Addendum No. 2

1/30/25

College of Southern Idaho Leroy Craig Center

**PROJECT: LeRoy Craig Jerome Center
College of Southern Idaho
Jerome, Idaho**

DRAWN BY: CI
CHECKED BY: JB
BID SET
DRAWING NO.
SL2.0
IRRIGATION PLAN

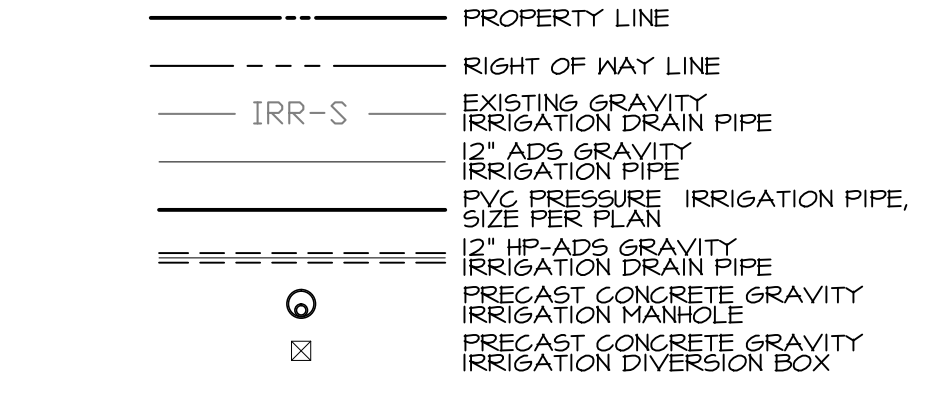
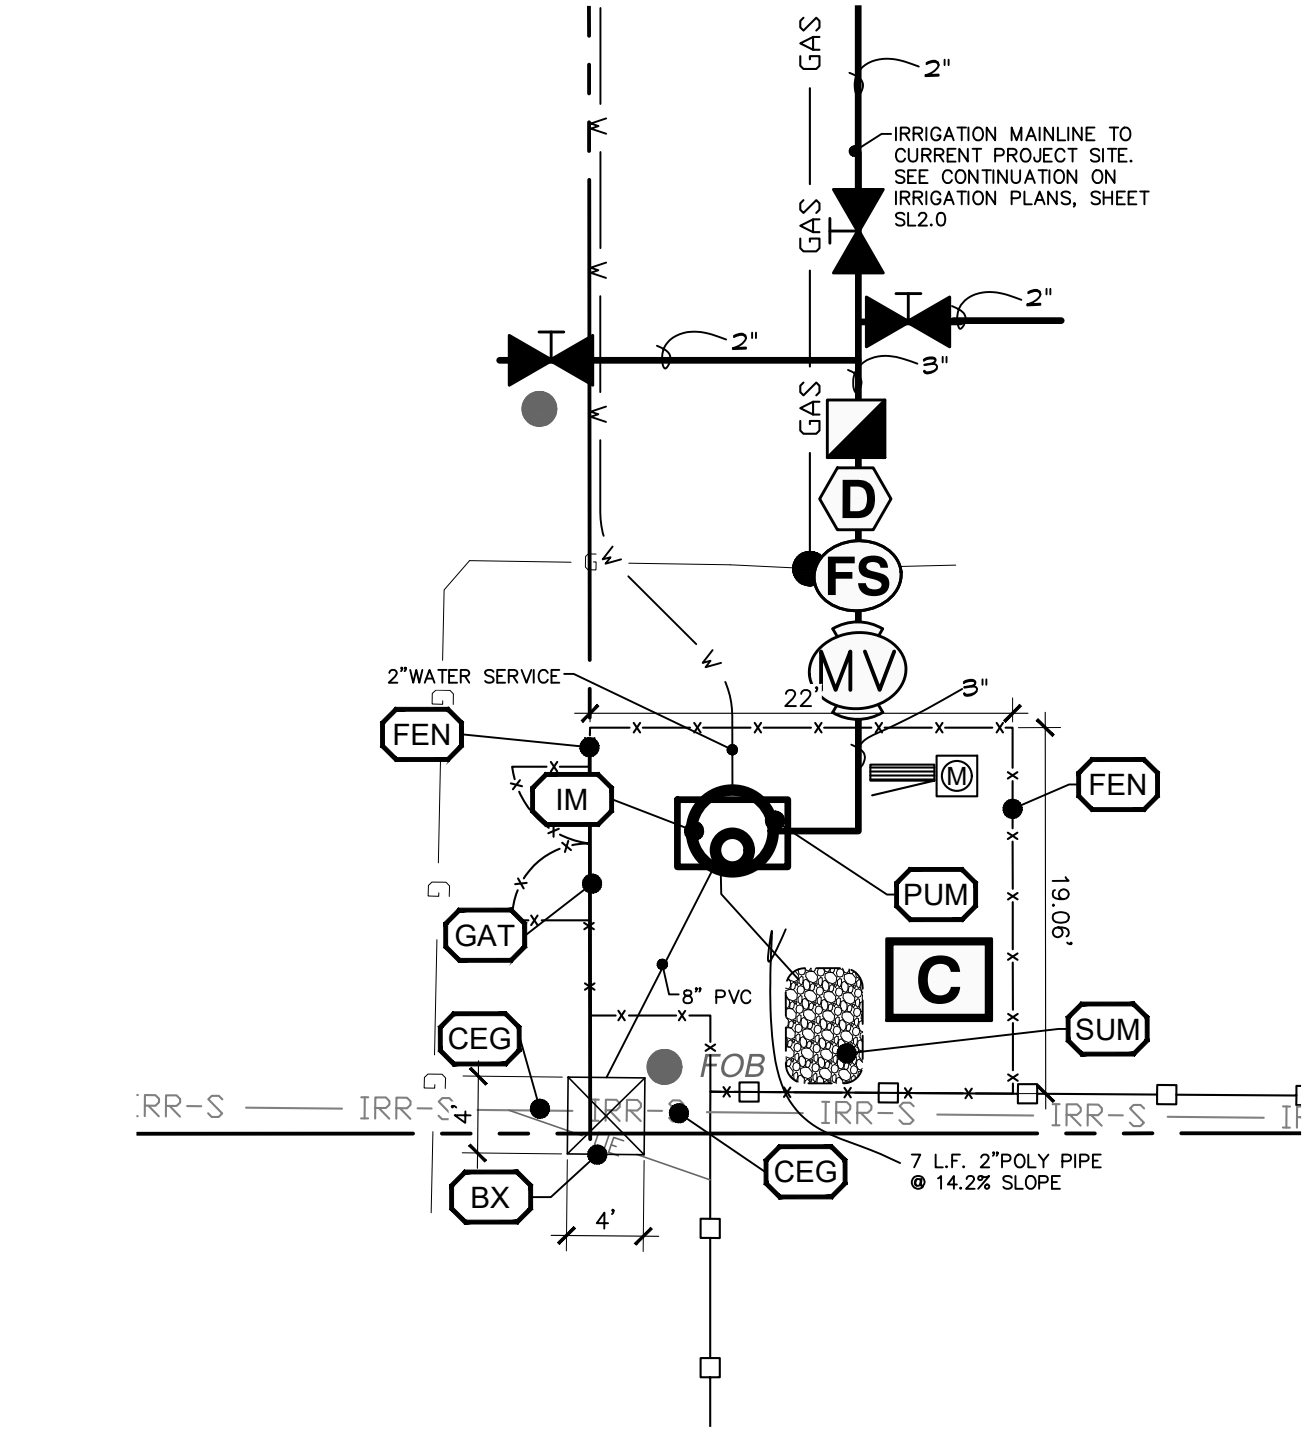
- 1-14 Sheet SL1.0, Revise plant locations around water meter vault.
- 1-15 Sheet SL2.0, Revise irrigation schedule valve sizes.
- 1-16 Sheet SL2.0, Revise drip irrigation location at tree grate locations.

- 1-17 Sheet SL2.0, Revise Backflow preventer location.
- 1-18 Sheet SL2.0, Modify mainline size per plans.
- 1-19 Sheet SL2.6, Replace detail 1.
